## **Service Bulletin TTC-SB-DHC3-04**

**Title:** Parallel/Series Start Master Relay Installation

**Effectivity:** All DHC-3 Otter aircraft modified with Texas Turbine Conversions, Inc. STC SA09866SC or Canadian STC SA02-15, turbine engine conversion modified with the Parallel/Series Service Kit – TTC-SK-DHC3-01 modified after December 1, 2006.

Figure 1

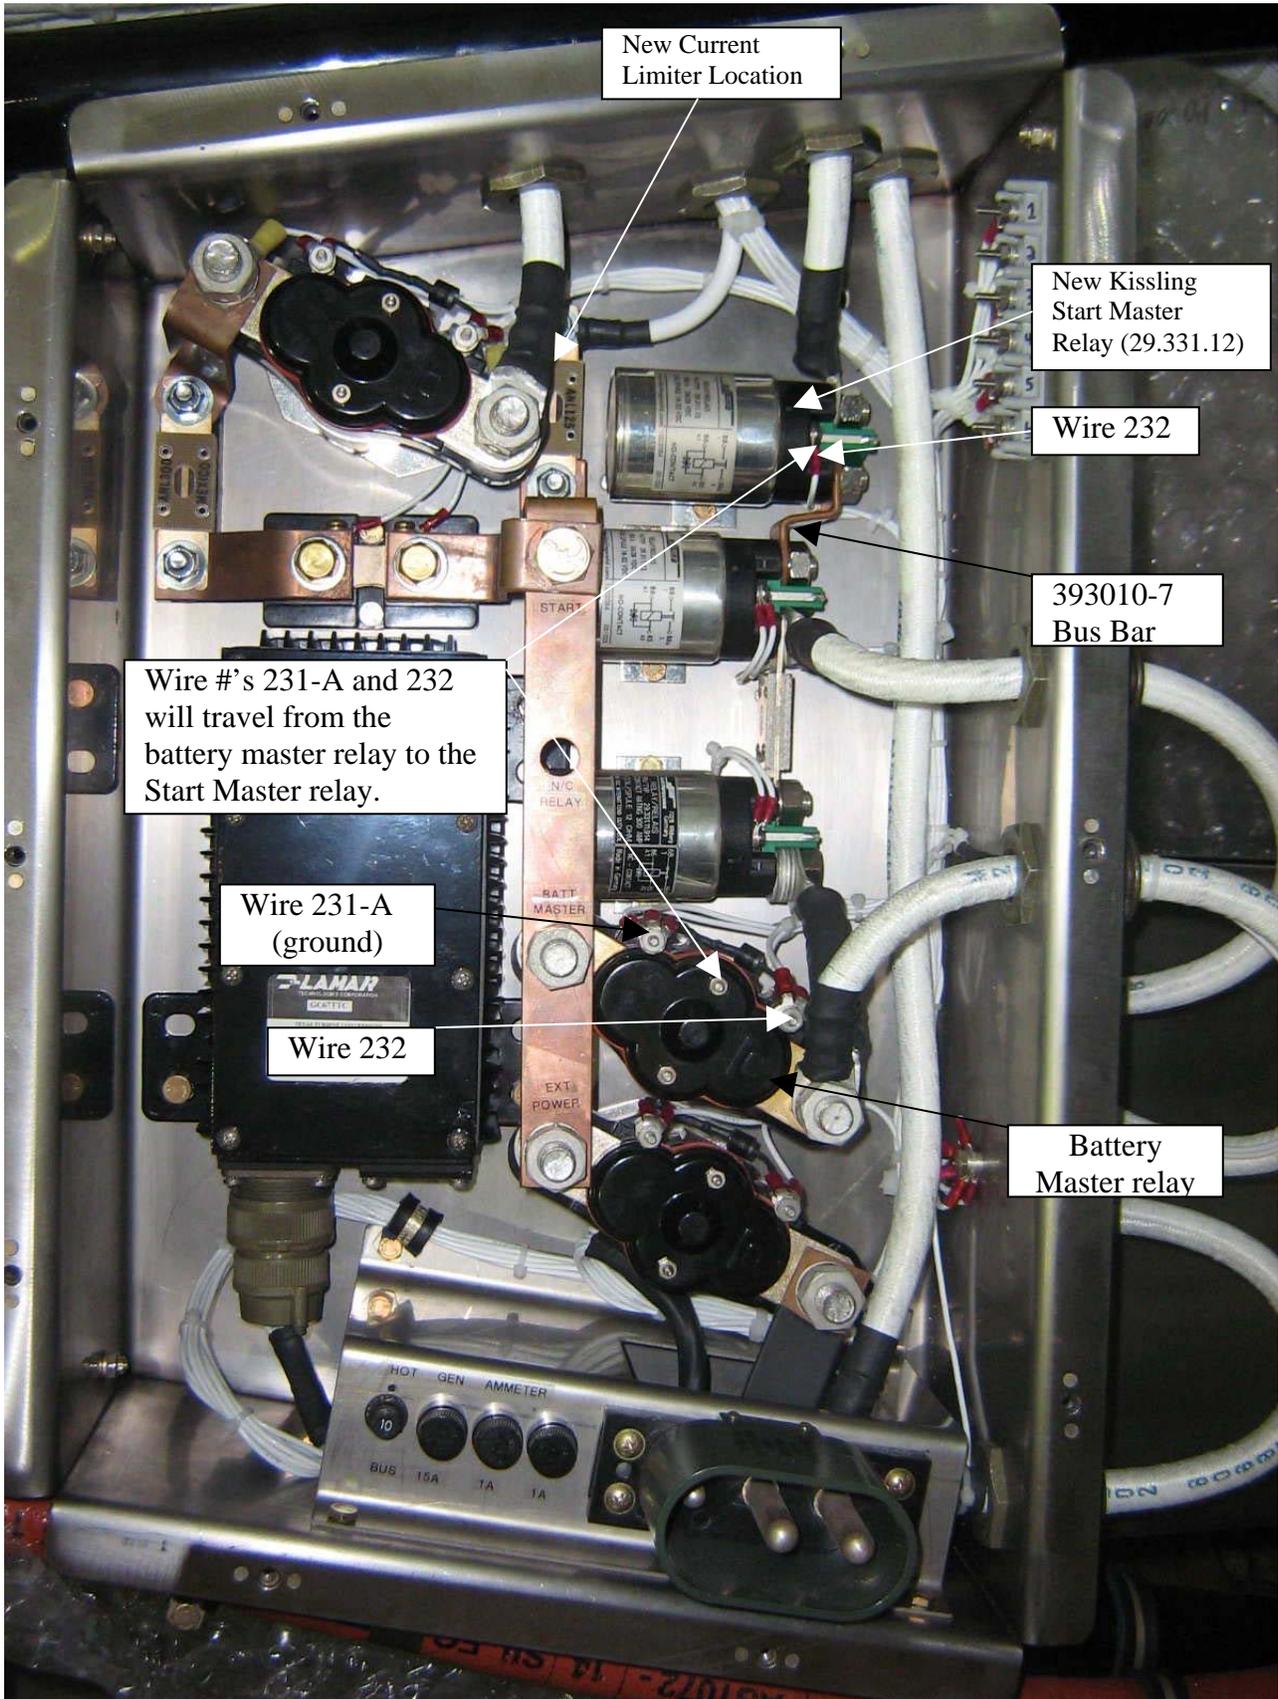
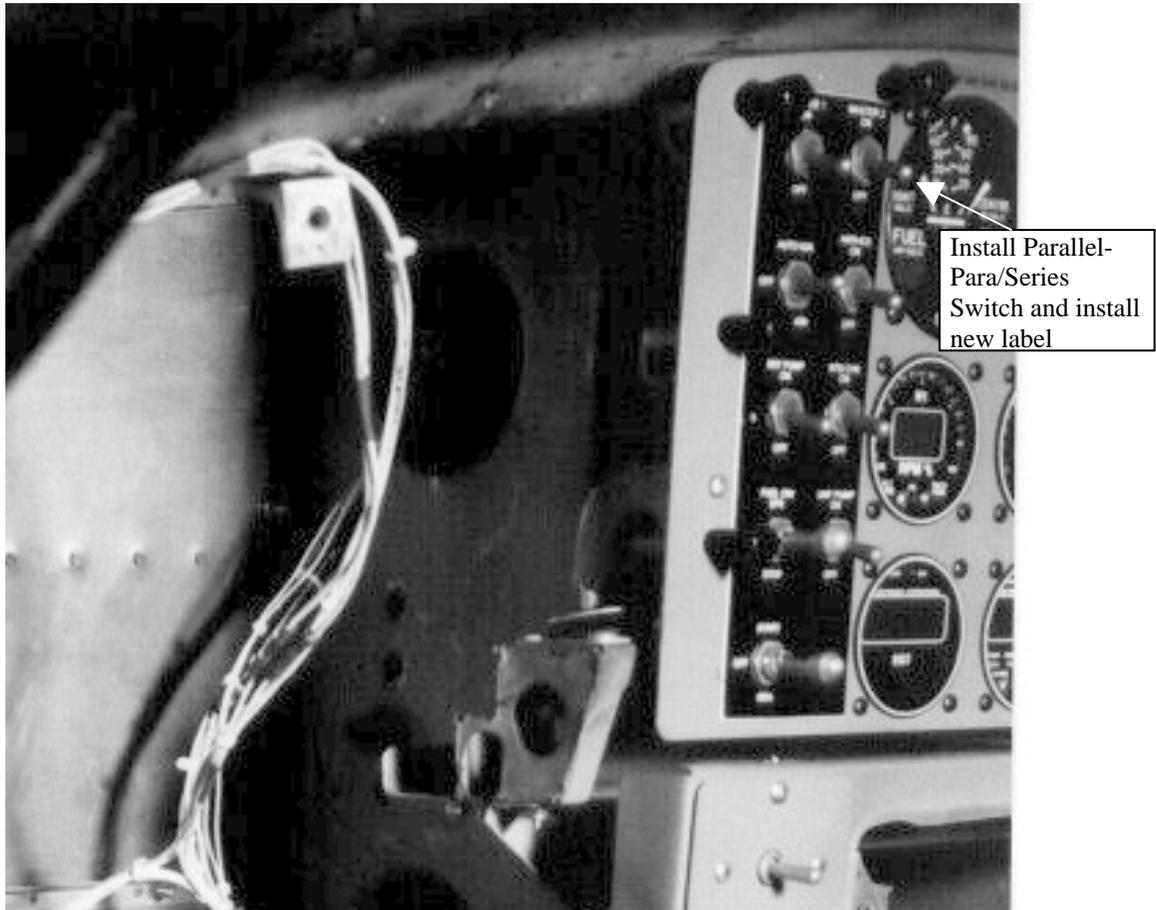
4. Remove the 125 amp current limiter, and the mount screws. Rotate the current limiter mount vertical and mark and re-drill the holes with a #10 drill and de-burr.( see fig. 1)

6. Then using the 393010-7 Bus bar for alignment, match drill and de-bur the start master relay (29.311.12) to J-box , fabricate and install wire 231-A on the A1 or 86 terminal of the start master relay and wire 232 on the A2 or 85 terminal ( utilizing MS22759/8-18-9 wire and #8 ring terminals). Mount the start master relay to J-Box with 2 bolts (AN3-4A), 2 washers (AN960-10), and 2 steel lock nuts (AN363-1032). ( see fig. 1)

- Cut the starter cable to the appropriate length (remove the 1/2" ring terminal) to attach to the (1 or 88) terminal of the new start mater relay. Crimp a 3/8"70-10 ring terminal on the cable and install it on the relay. (see figure 1 for ring terminal clocking)
